STAFF REPORT: APRIL 13, 2022 MEETING PREPARED BY: A. DYE

APPLICATION NUMBER: 22-7752

ADDRESS: 15004 WARWICK

SCOPE: REPLACE WOOD WINDOWS WITH VINYL WINDOWS

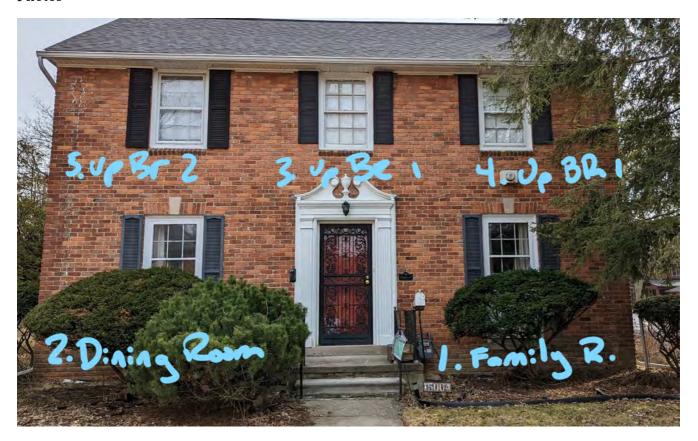
- The applicant states the original windows are suffering from condensation that is trapped between the storm and wood sash, and that he has attempted to maintain the windows. The windows do not appear to be highly deteriorated, likely in part to the owner's proactive care. The condensation may be caused by storm windows that do not have weep holes (or that the weep holes have been covered with caulk), whose purpose is to prevent/minimize moisture from being trapped against the window sash.

- o It is possible the wood windows can be repaired by an experienced window repair company, and the installation of better fitting storms that offer weep holes may not only take care of the existing problems, but may offer greater thermal insulation than new plastic window framed units.

- The applicant expresses his wish for uniformity of window openings. There are 19 windows on the house, and only six are vinyl. The architectural integrity of the house is better served to retain the wood windows and eventually replace the vinyl windows with wood (true or simulated divided light) units once they inevitably deteriorate.

- Vinyl windows are not appropriate for historic houses, as the level of detail of a true-divided light window can not be matched by current vinyl production methods. Even though the storm window on the wood unit partially obscures the dimensionality of muntins when looking at the window from a distance, once up close, the dimensionality is noticeable and retains equal dominance with the profile of the wood brickmold. The vinyl window frame is boxy and flat, and makes the window sash look even more recessed. Additionally, the muntins of the vinyl unit are flat and in shadow, as they are recessed behind the glass. They add very little to the definition of the window unit and window opening.

It is staff's opinion the replacement of the existing wood windows with new vinyl windows will alter the features and spaces that characterize the property. Staff therefore recommends the Commission issue a denial for the work as proposed because it does not meet the Secretary of the Interior Standards for Rehabilitation and the Elements of Design for the district, specifically Standards:

4. Upstairs Bedroom 1 Exterior, Interior, and Interior Detail.

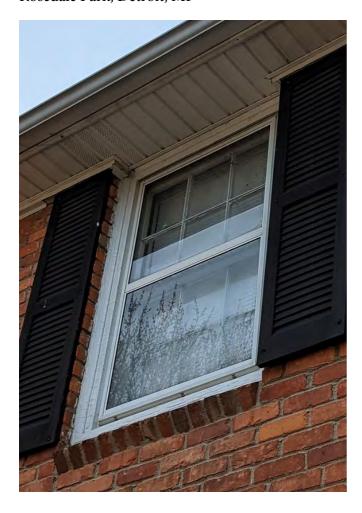
*Note Storm is missing completely from this window and lets in a massive draft. In the exterior photo you can notice fresh window glazing that is unpainted due to weather temp dropping last year before we could complete the restoration of the panes. Major mold growth this year discovered at time of taking these photos.
